Applies To: **2007–08 Fit** – Check the iN VIN status for eligibility

October 18, 2013

Safety Recall: 2007–08 Fit Power Window Master Switch May Not Work (Replaces 10-008 and 13-052, Safety Recall: 2007–08 Fit Power Window Master Switch May Not Work)

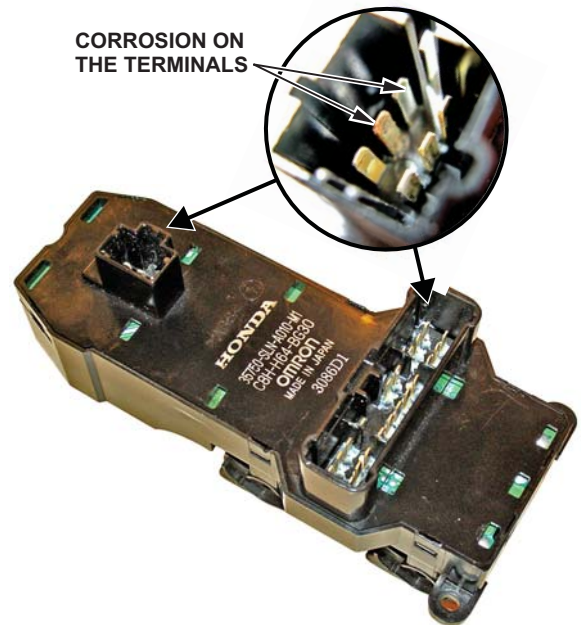
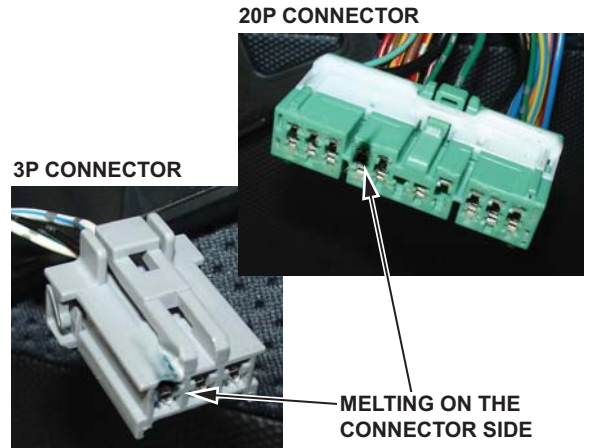
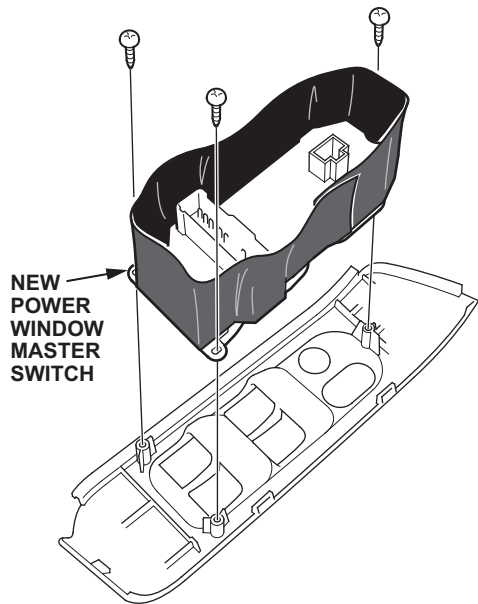
5. Check for corrosion or melting on the switch side and the harness side of the 3P and 20P connectors:

- If there is no corrosion on the terminals and no melting on the connectors, go to step 6.
- If any of the terminals have corrosion, or if any of the connectors are melted, replace the driver's door wire harness and the power window master switch, then go to step 6.

Check for gaps along the seal edge.

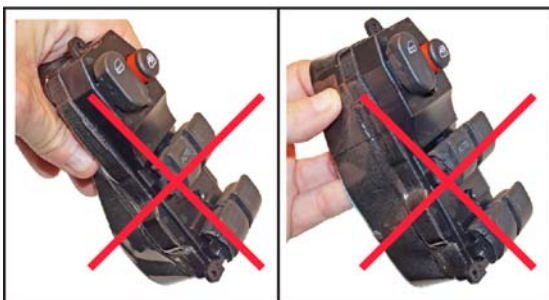
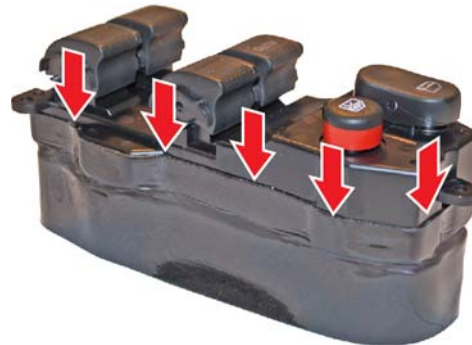
- The replacement switch comes with an acrylic seal attached. Make sure you handle the switch by the switch body to avoid damaging the seal.

- Before installing the replacement switch, make sure the seal is not damaged and there are no gaps between the seal and the switch body. **If there is any seal damage, or gaps between the seal and the switch body, replace the switch.**
